## **SERVICE BULLETIN**

### **SERVICE BULLETIN INDEX**

FIGURE 3  
BLANKING CONNECTOR ASSEMBLY INSTALLATION

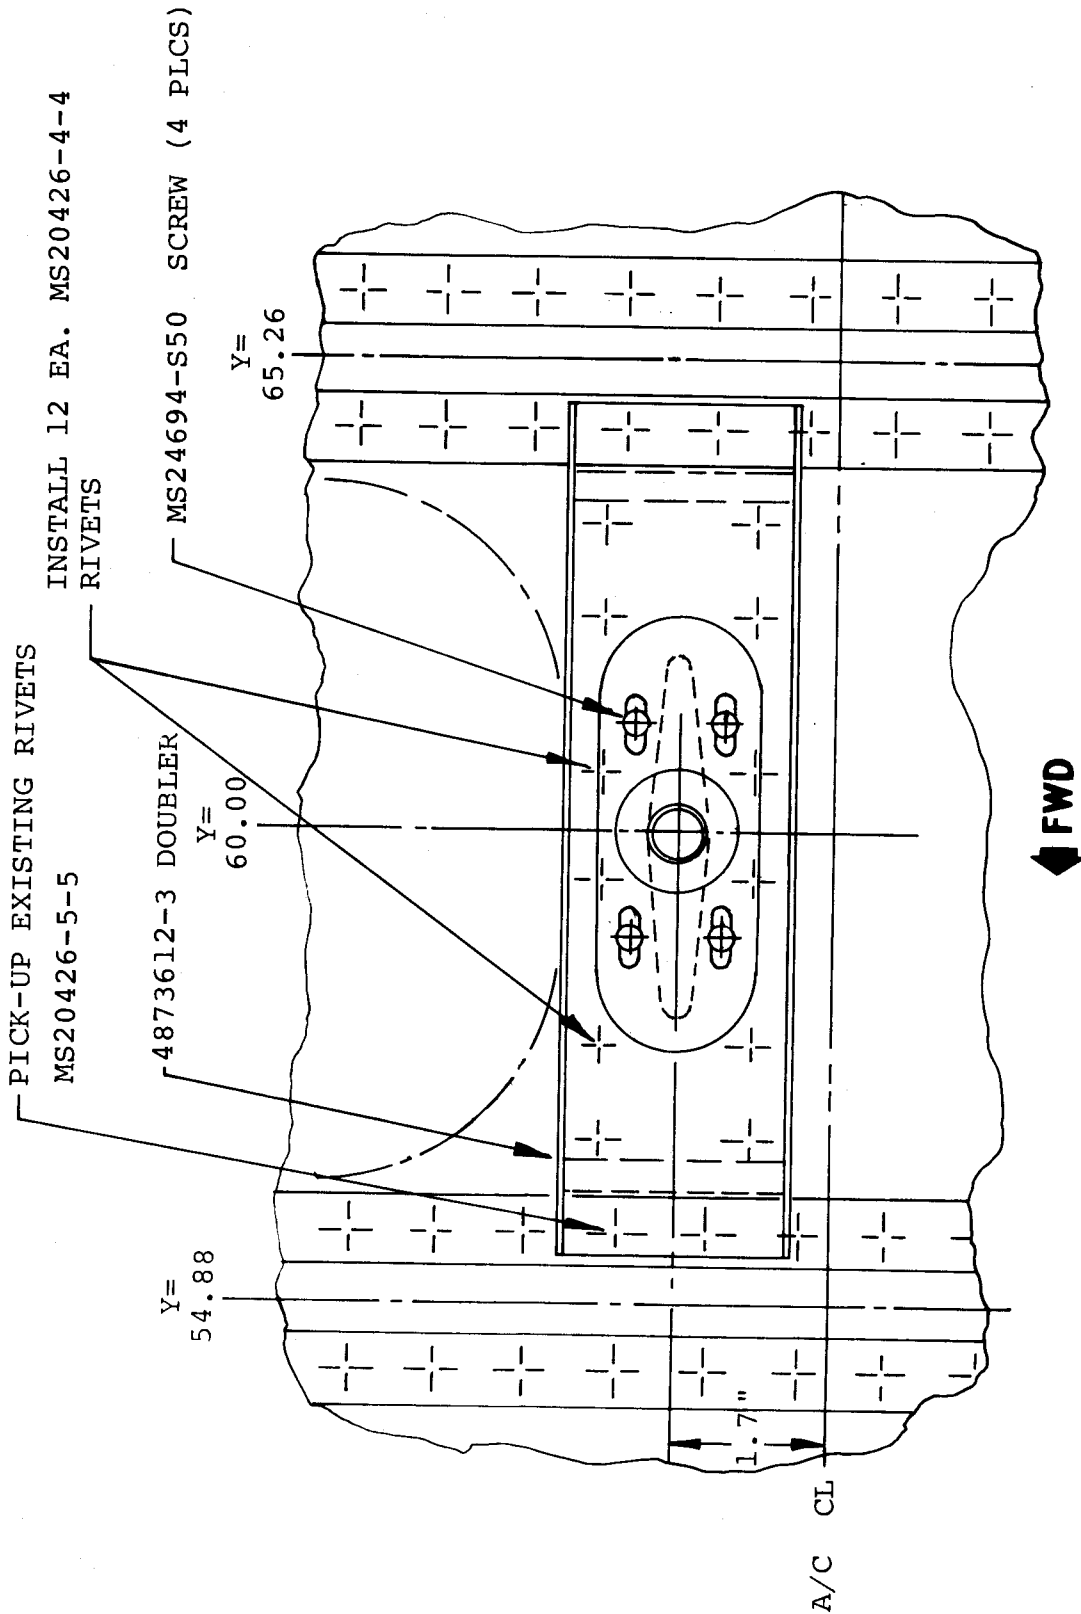
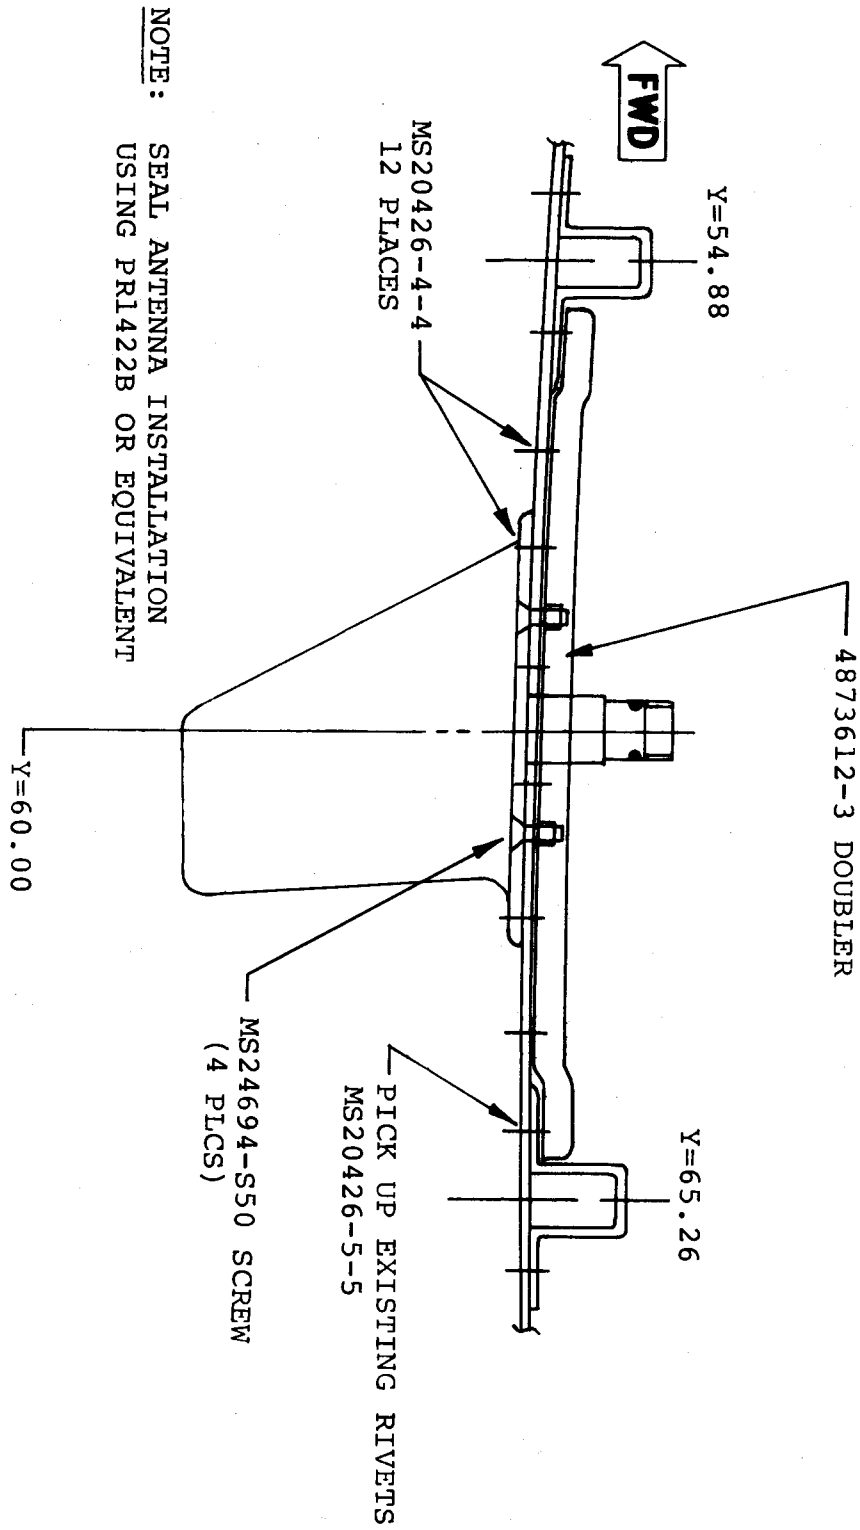
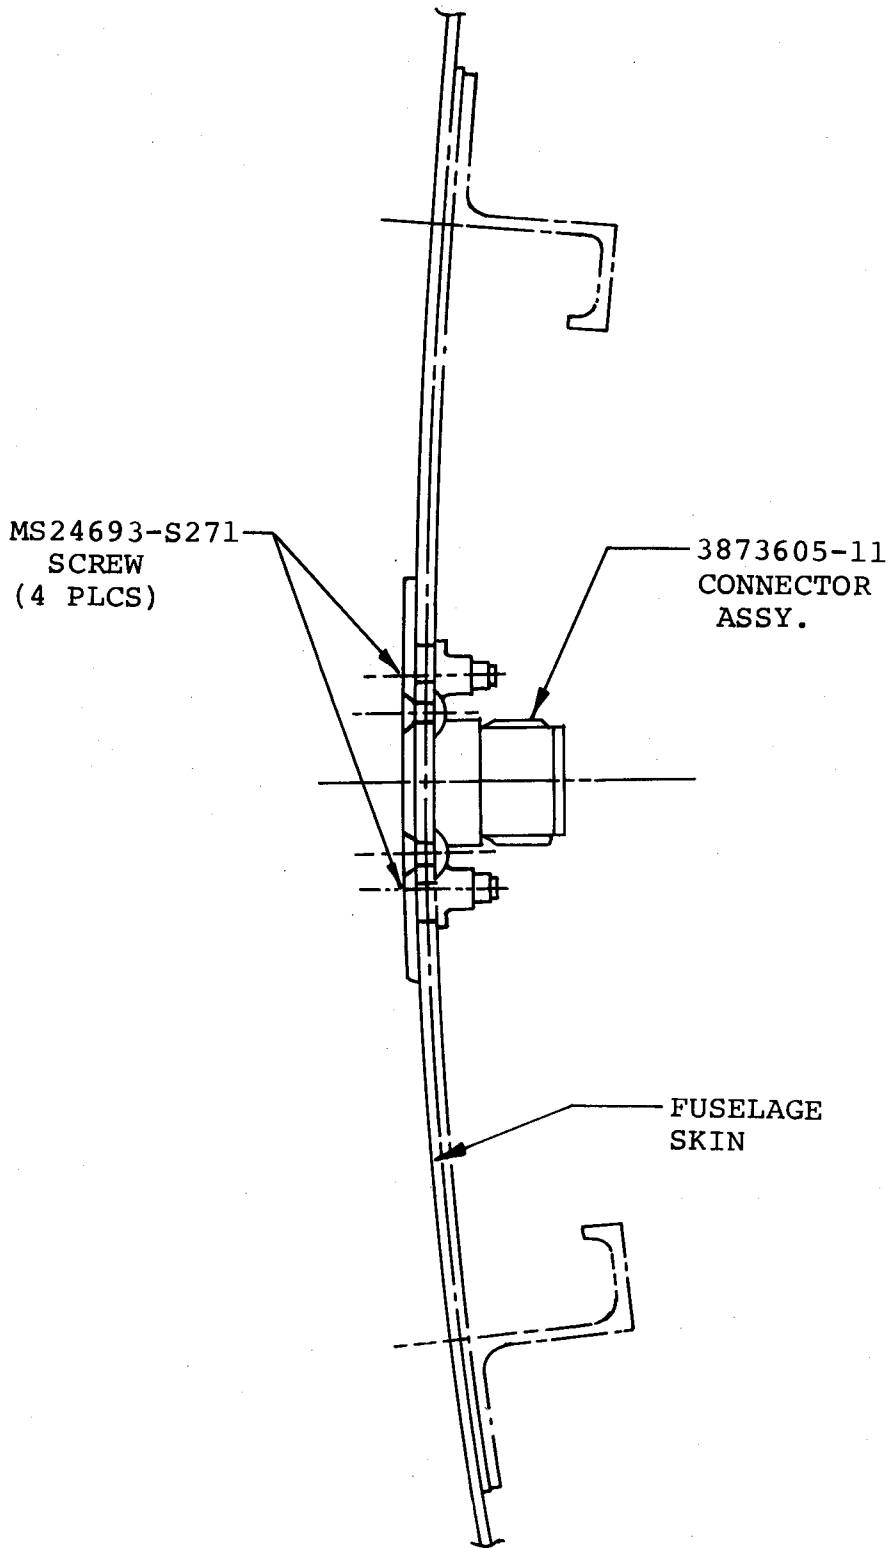
1. Disconnect coaxial antenna lead.
2. Remove existing flight telephone antenna.
3. Install blanking plate connector assembly P/N 3873605-11 using 4 ea. screws MS24693-S271. Apply PRL422B as required. Ref. Figure 3.
4. Connect the existing coaxial antenna lead to the blanking plate dummy connector and secure lead as required.

FIGURE 1

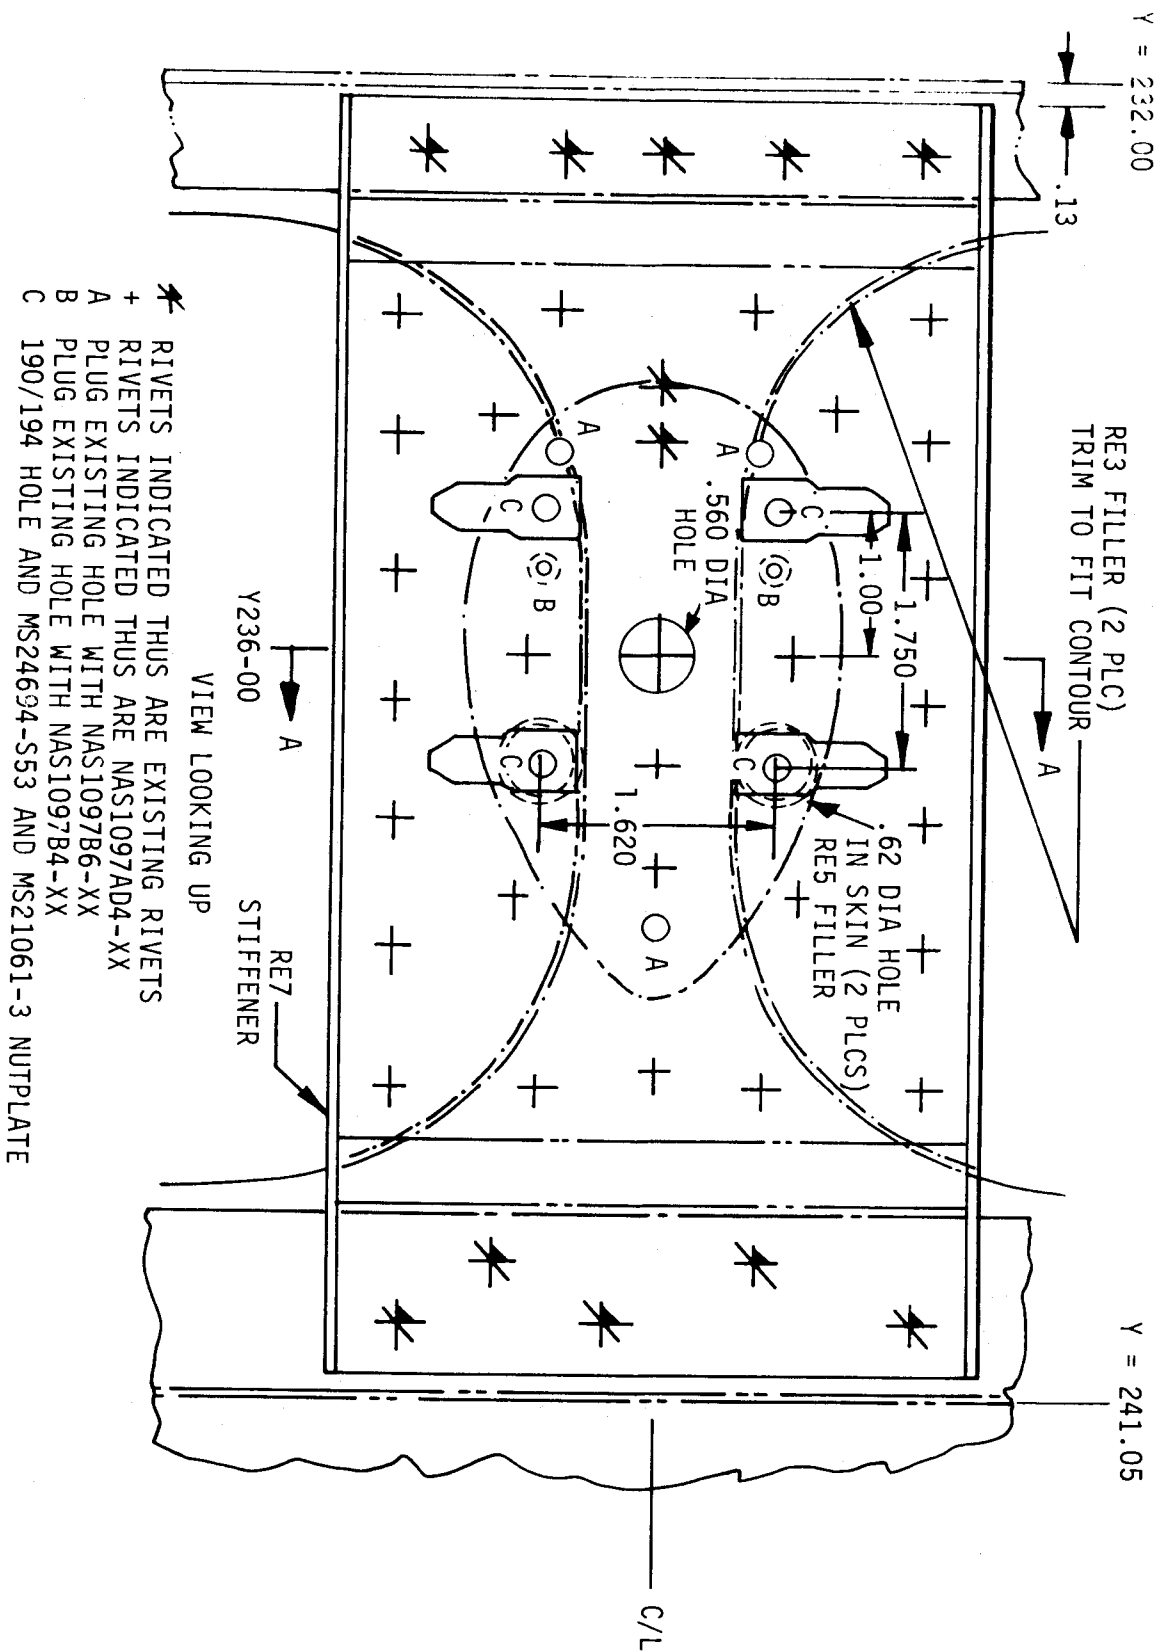
DMQ18-3 ANTENNA INSTALLATION

(FIGURE 2 - KIT A)

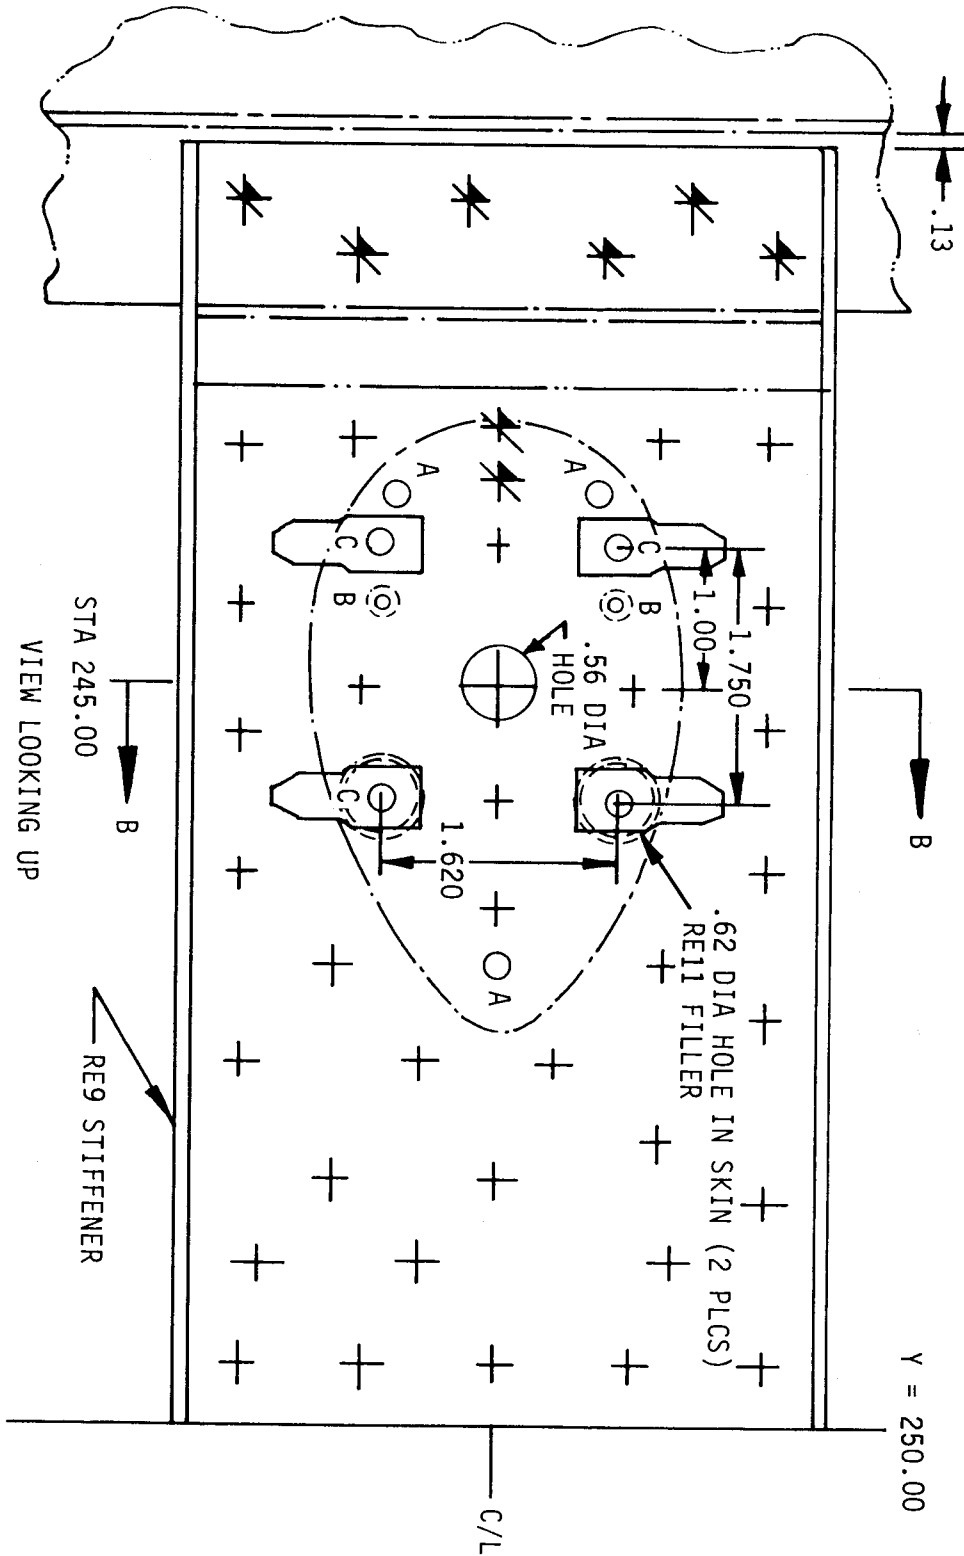
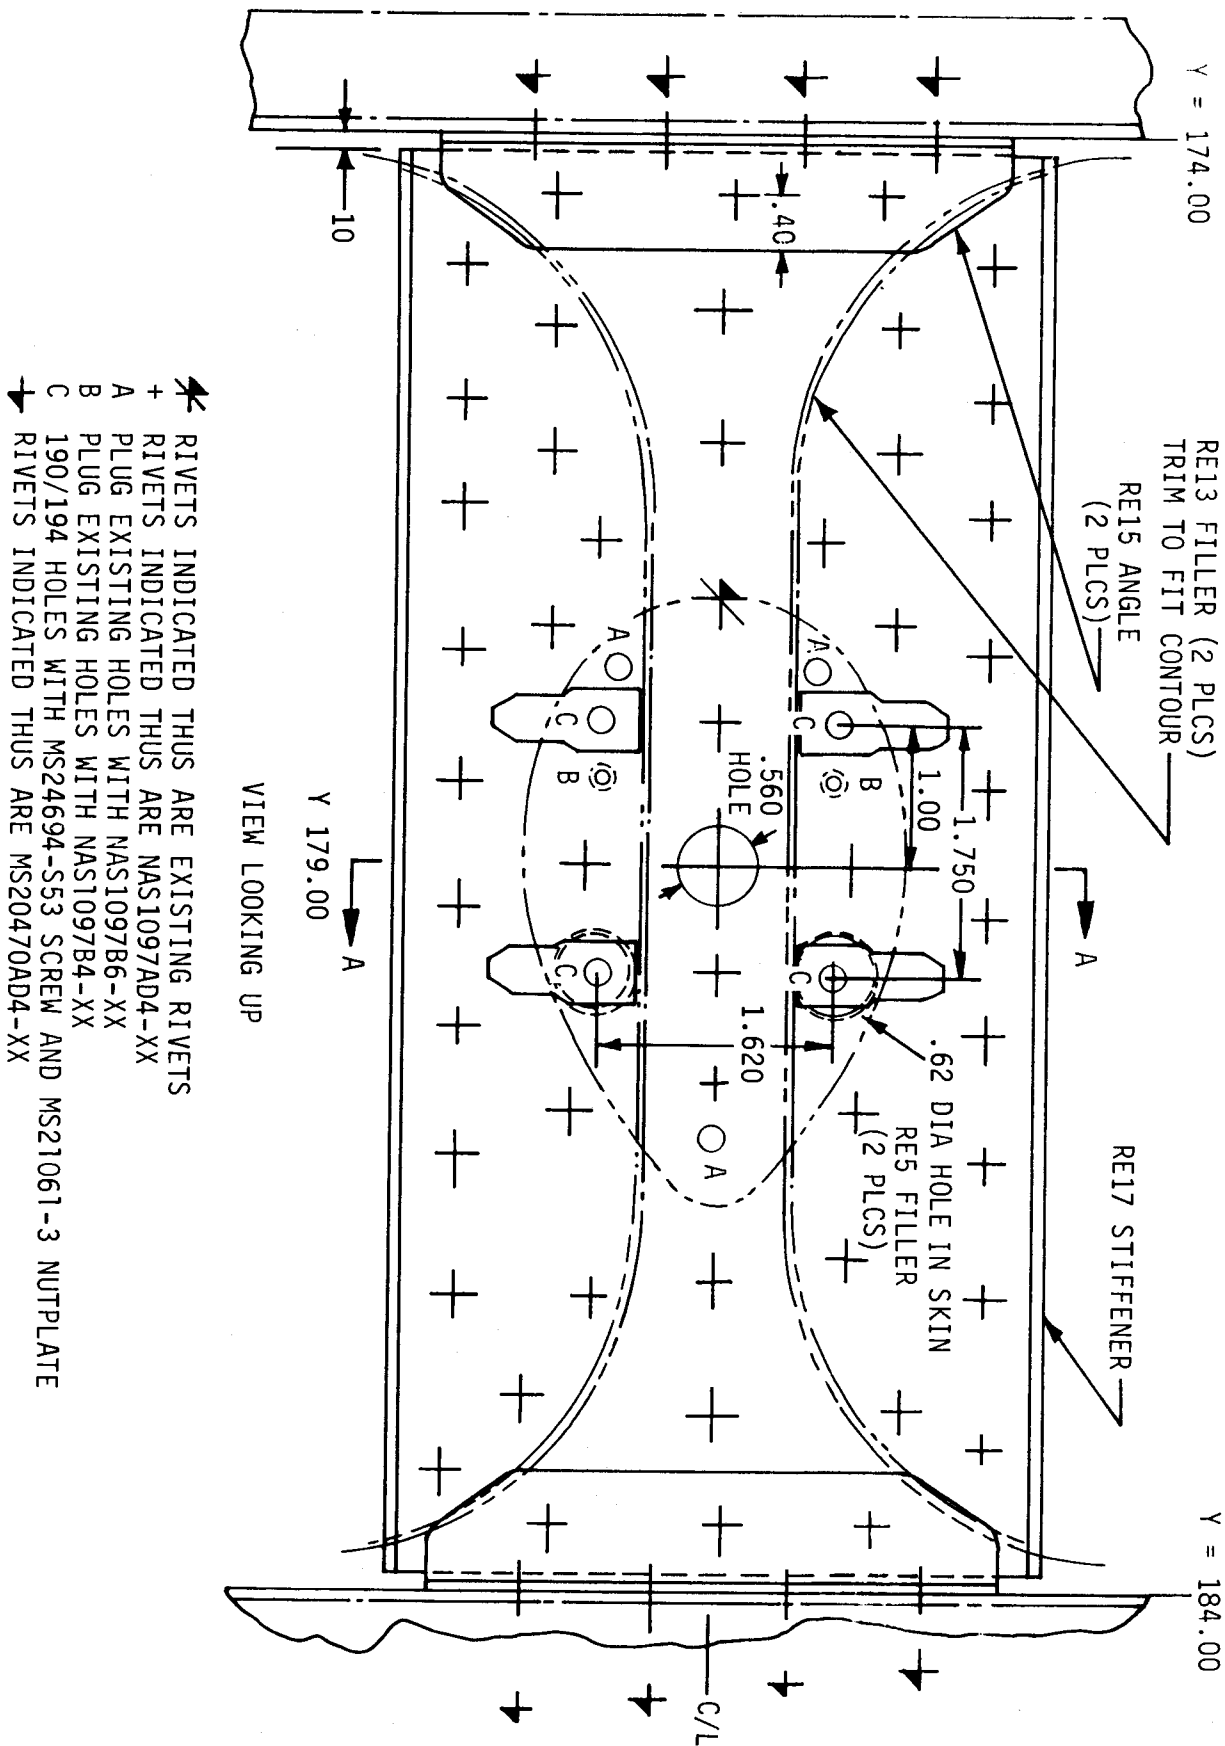
- F. Select doubler from Kit A, B or C as appropriate. Lay out rivet hole pattern in doubler and pre-drill from 1/8" rivets on bench. Hold doubler in place and drill from bottom through skin and doubler. Remove and attach four appropriate nut-plates to doubler for mounting bolts. Drill out clearance hole for coax connector. Install doubler with the required fillers as shown in Figure 2.

FIGURE 1

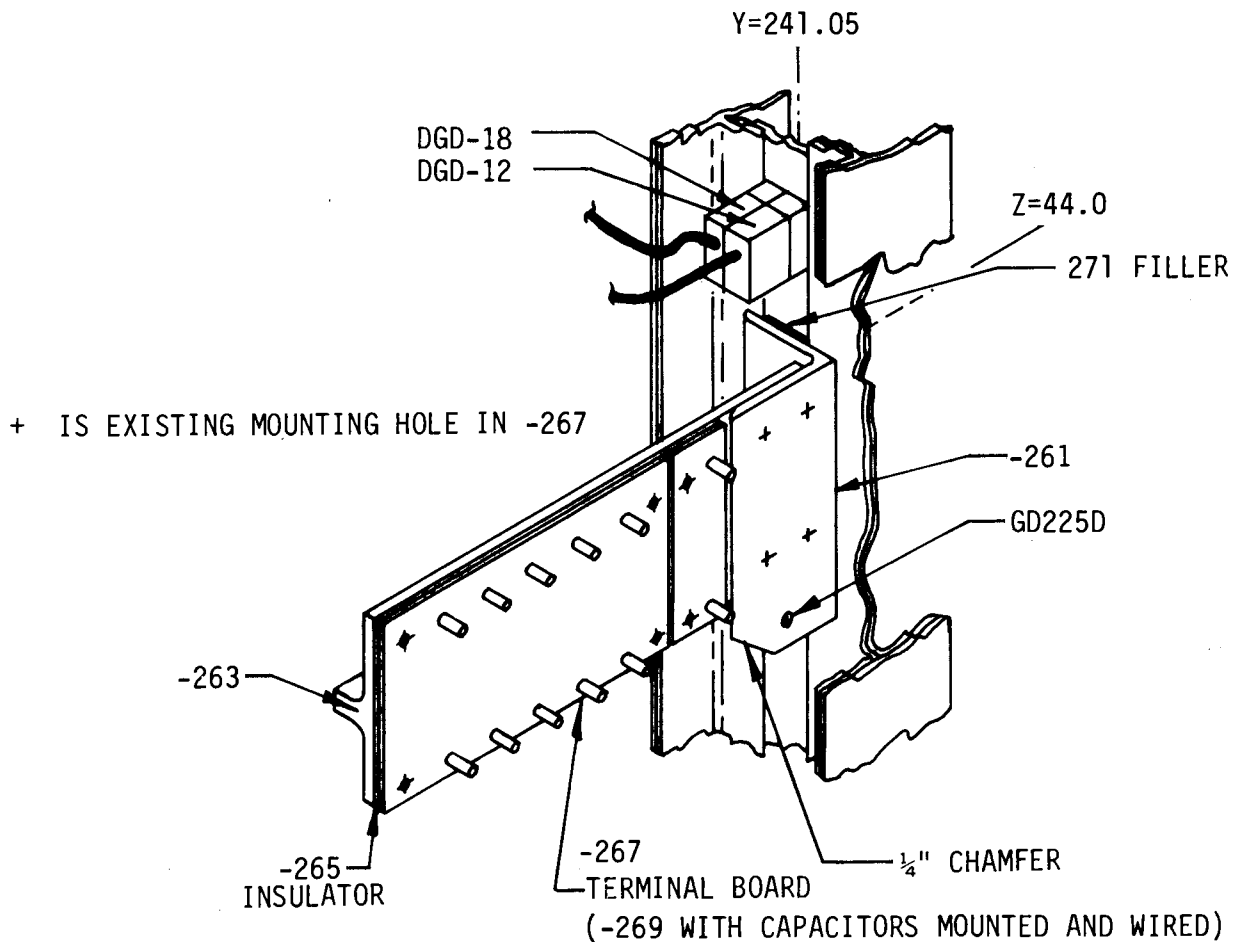
- A. Remove all power from aircraft (reference Figure 1 for the following steps).
- B. Gain access to terminal strip T-25 and bulkhead at Fuselage Station 241.05 (LHS) by removing the rear (outboard) panel from the aft coat closet.
